**COON CREEK WATERSHED DISTRICT**  
**Request for Board Action**

**MEETING DATE:** February 12, 2024  
**AGENDA NUMBER:** 11  
**ITEM:** Blaine Crossing - My Salon

**Permit Application Review Report**  
**Date: 2/8/2024**

**Project PAN:** P-23-073

Figure 1: Site Plan

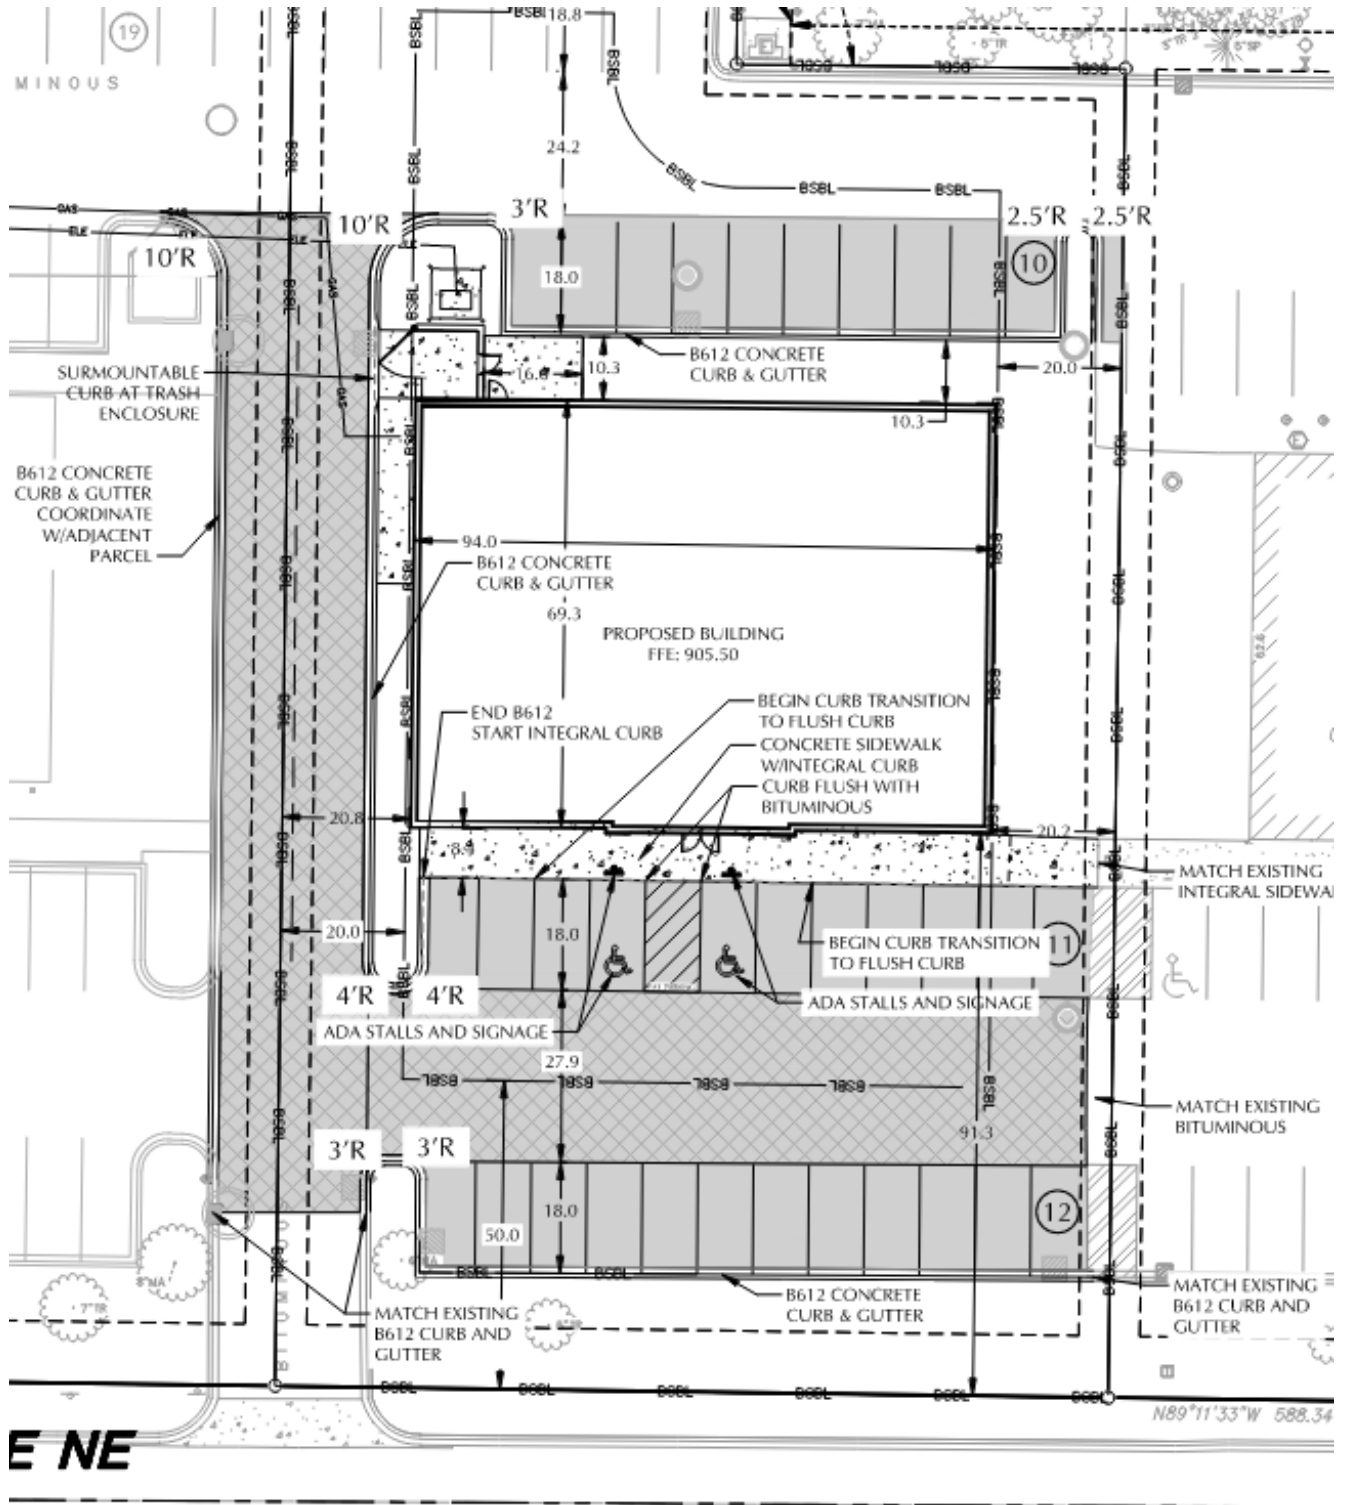
**Description:** The project proposes the construction of a new commercial building, parking lot and associated stormwater treatment features. The project will construct onsite infiltration and utilize an existing regional pond. The project will create 0.56 acres of regulated impervious which ultimately drains toward County Ditch 41. See Figure 1: Site Plan (attached).

Figure 2: Erosion and Sediment Control Plan

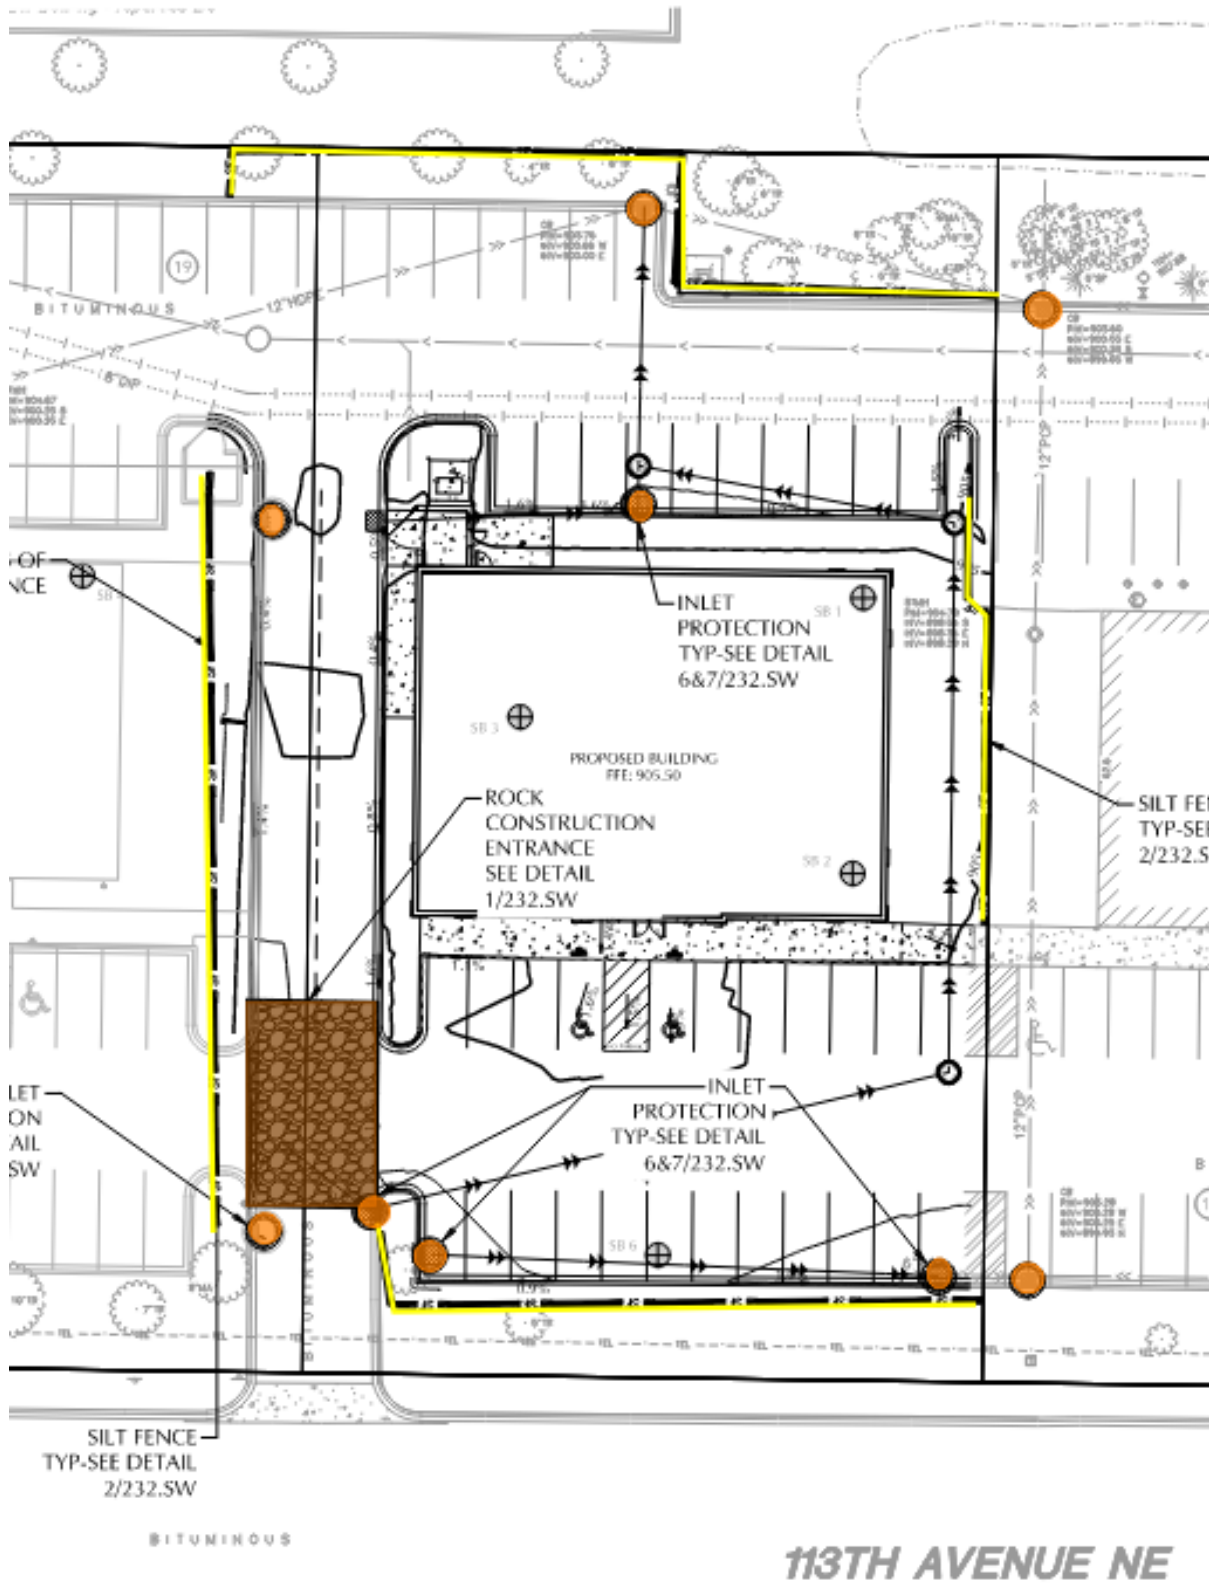
The proposed project drains to County Ditch 41. The soils affected by the project include Zimmerman and have a soil erodibility factor of 0.15 or greater. Disturbed areas are proposed to be stabilized within 7 days, as required. The proposed erosion and sediment control plan includes perimeter control, rock construction entrance and inlet protection. The erosion control plan meets District Requirements. See Figure 2: Erosion and Sediment Control Plan (attached).
